SERVICE INSTRUCTION

EQUIPMENT: VC-401C

SERVICE INSTRUCTION NUMBER: WSI VC-401C-14

Revision A

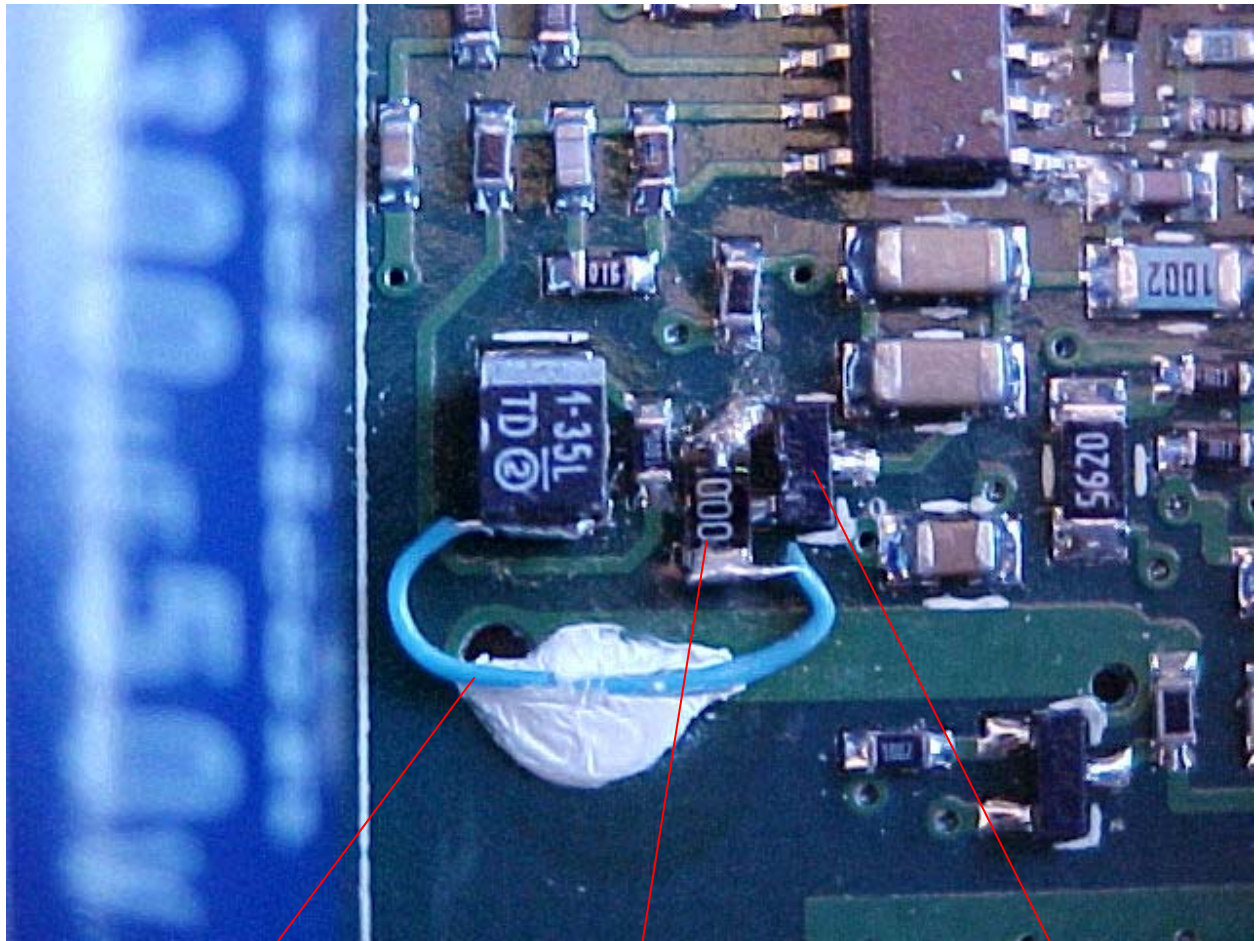
To prevent excessive modulation of the PA at low-end frequencies which varies by voice input modulation.

Install new resistor R410 between the un-terminated leg of CR3 and ground in the PA loop amplifier circuit.

1. Solder a 100 ohm resistor (item 1, R410) to pin 1 of CR3.
2. Solder item 2 or equivalent from R410 to the ground side of C55.
3. Apply MIL-I-46058C compliant conformal coating to newly installed part(s).
4. Identify the unit with the procedure as described and reassemble the unit in reverse order of disassembly.
